SUBJECT: SPENT FUEL POOL EXPANSION

Re: Oyster Creek Nuclear Generating Station

SAFETY EVALUATION BY THE OFFICE OF NUCLEAR REACTOR REGULATION
SUPPORTING AMENDMENT NO. 76 TO PROVISIONAL OPERATING LICENSE NO. DPR-16

GPU NUCLEAR CORPORATION AND
JERSEY CENTRAL POWER & LIGHT COMPANY
OYSTER CREEK NUCLEAR GENERATING STATION

Figure 1. Dynamic Model

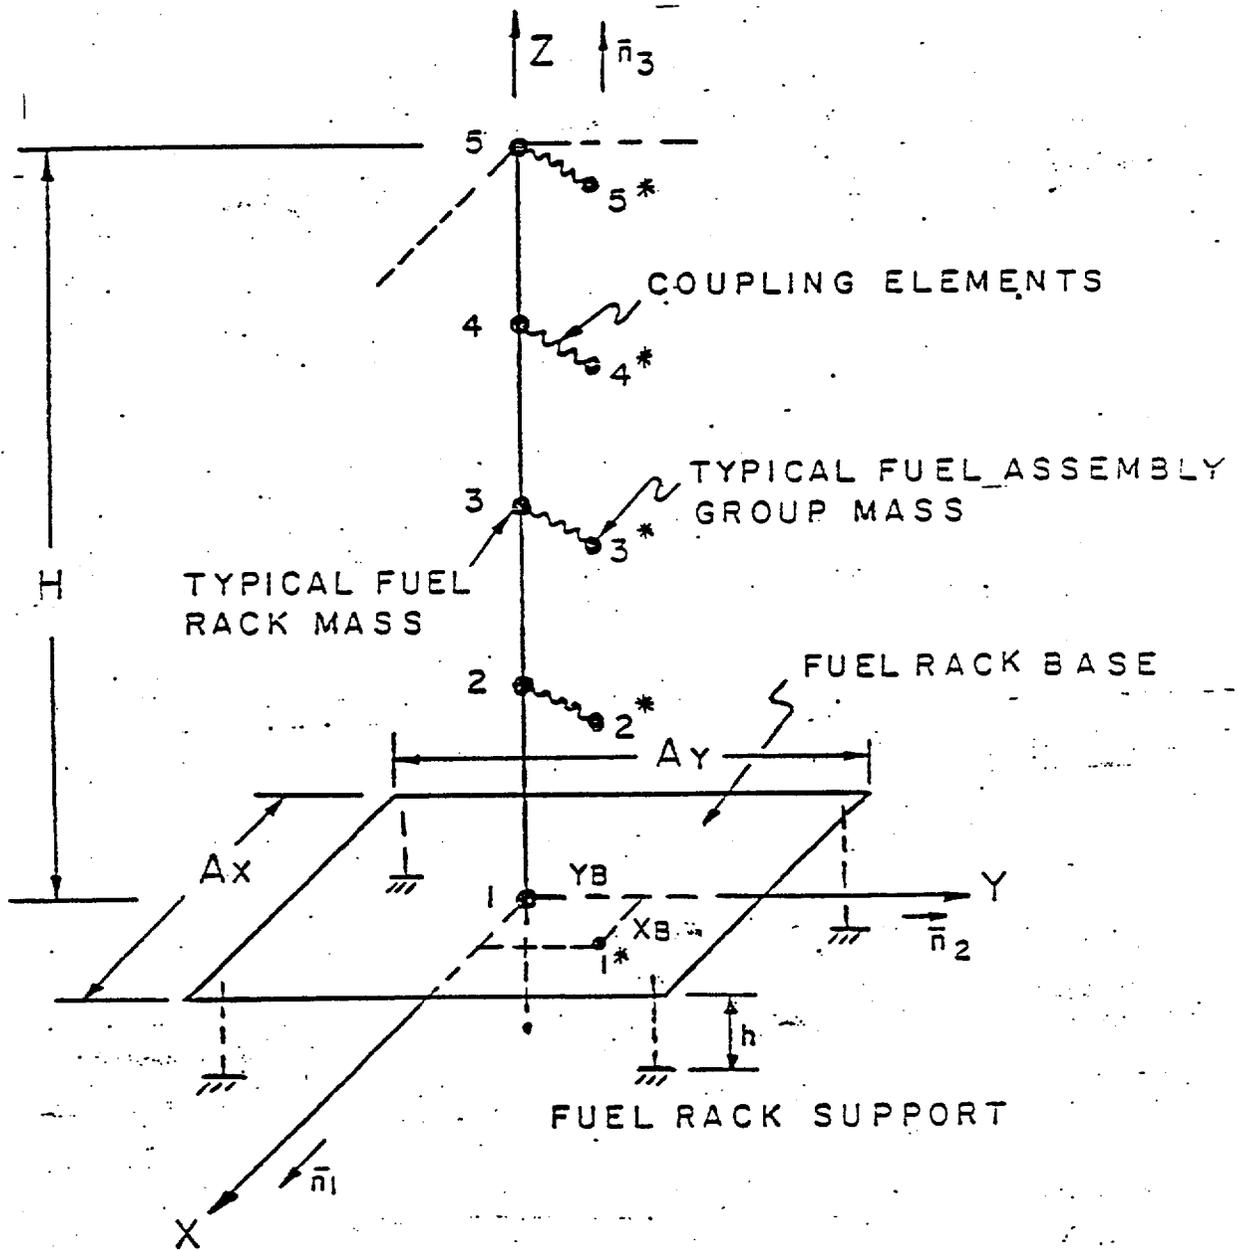
Since the Licensee has not taken any credit for impact structural damping of the limber fuel assembly, it appears that a small amount of damping could be justified as either impact damping or equivalent fluid drag without compromising the conservatism of the analysis.

The lumped mass approach was used in the dynamic model, wherein the mass of the fuel rack was lumped at five equidistant locations as shown in Figure 1. For horizontal motion, the rack mass was proportioned at one-quarter of the total mass for each of the three middle mass nodes and at one-eighth of total mass each for the top and the bottom nodes. The mass of the base plate and support structure was lumped with the bottom node. For the fuel assemblies, five lumped masses were used in a similar pattern of distribution. For vertical motion, two-thirds of the racks' dead weight acted at the bottom mass node, with the remaining one-third applied at the top node. All of the dead weight (gravitational force) of the fuel assembly was at the bottom node.

Figure 2. Module Layout

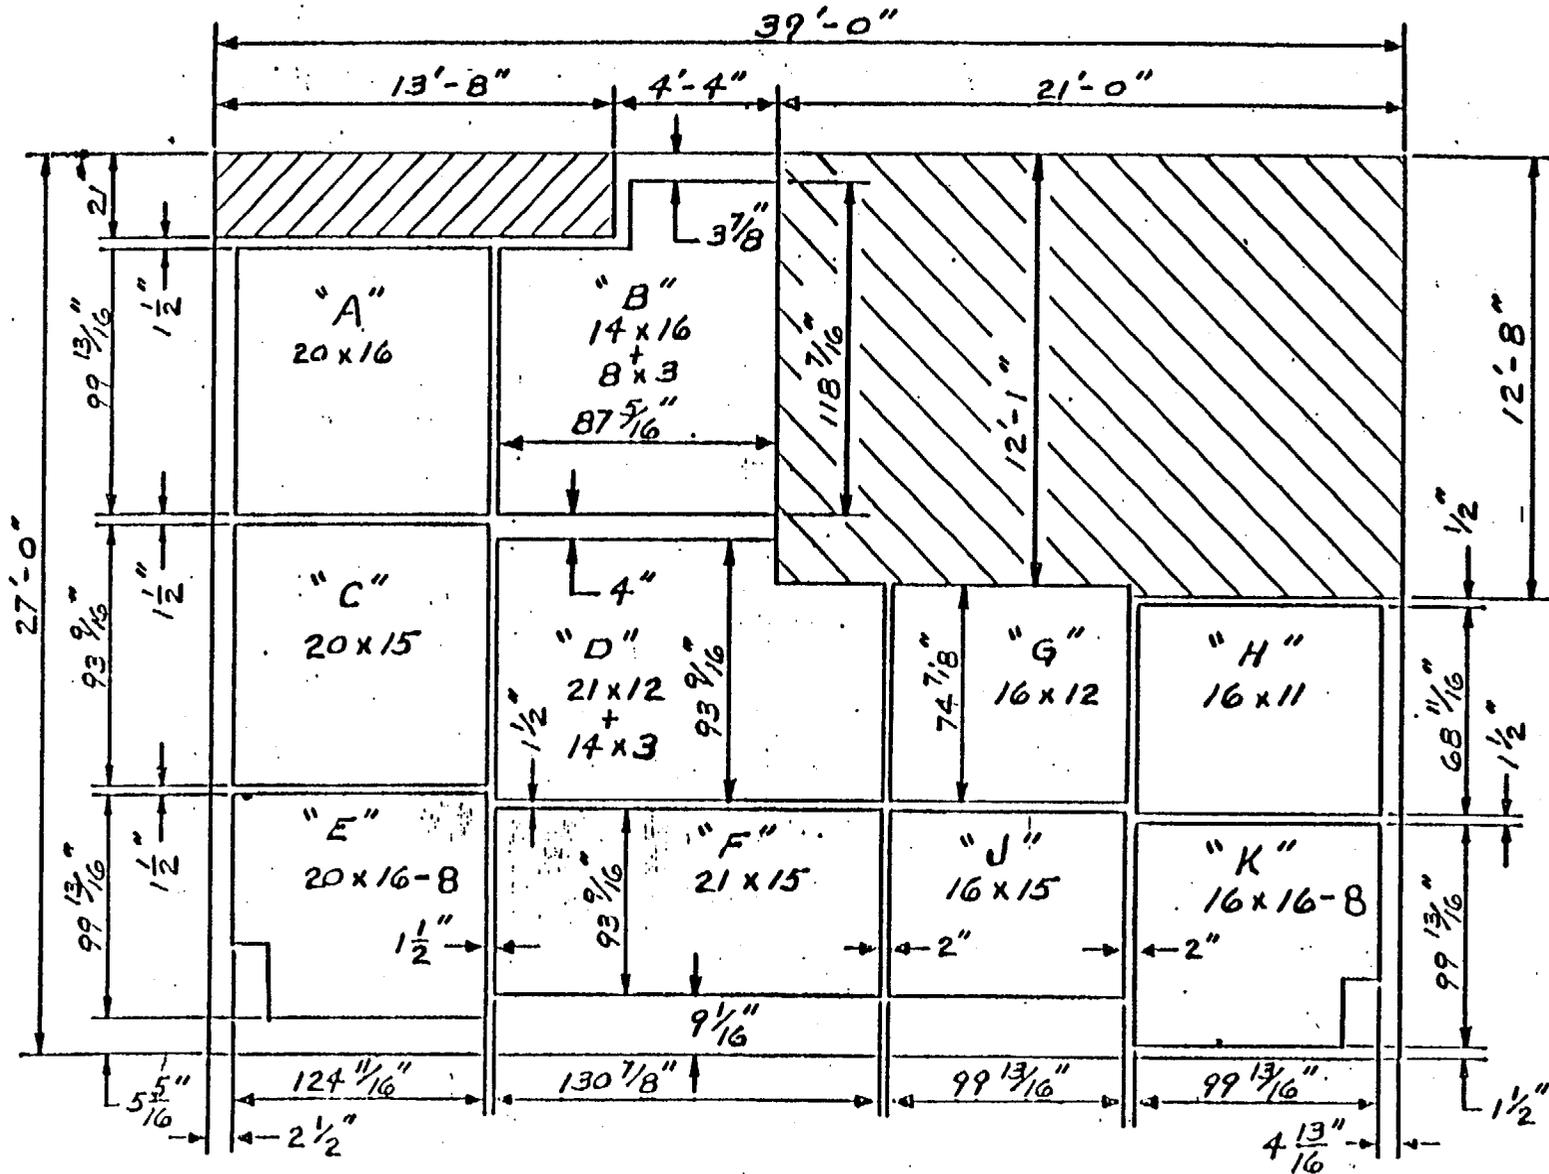
As indicated in the Licensee's submittals [1, 3], one of the Licensee's structural acceptance criteria is the kinematic criterion. This criterion seeks to ensure that adjacent racks will not impact during seismic motion. As shown in Figure 2, gaps between racks vary from rack to rack. In response to FRC's list of questions [13], the Licensee stated that an equivalent gap was

used to simplify the inter-rack interaction problem to a standard configuration [9]. This equivalent gap will form a bounding space around the rack, which fluid is assumed not to cross.

It was noted that rack module F had a maximum computed displacement of 1.298 in, whereas the installed clearance with the adjacent module was 1.5 in as shown by the Licensee's Figure 2.1 [1]. Thus, 1.298 in was greater than half the 1.5-in gap (0.75 in), but the combined displacement of E and F was less than the total clearance.

The first item in the listing of additional data, and showing a dynamic response displacement of 0.172 in, was computed for rack module F under the same physical conditions as yielded 1.298 in in the original data. The difference appears, from the Licensee's study, to be due to the lack of convergence of the numerical solution with the larger time step. While, as discussed in Section 3.3.6, more data points on the convergence curve of the Licensee's study are required to provide full confidence that adequate convergence is reached with an integration time of 0.00002 sec, the Licensee presented [10] evidence indicating that convergence may have been reached. Thus, instead of a displacement of 1.298 in, a fully converged solution would be on the order of 0.17 in to remove questions of possible impacting under the conditions as mentioned above.
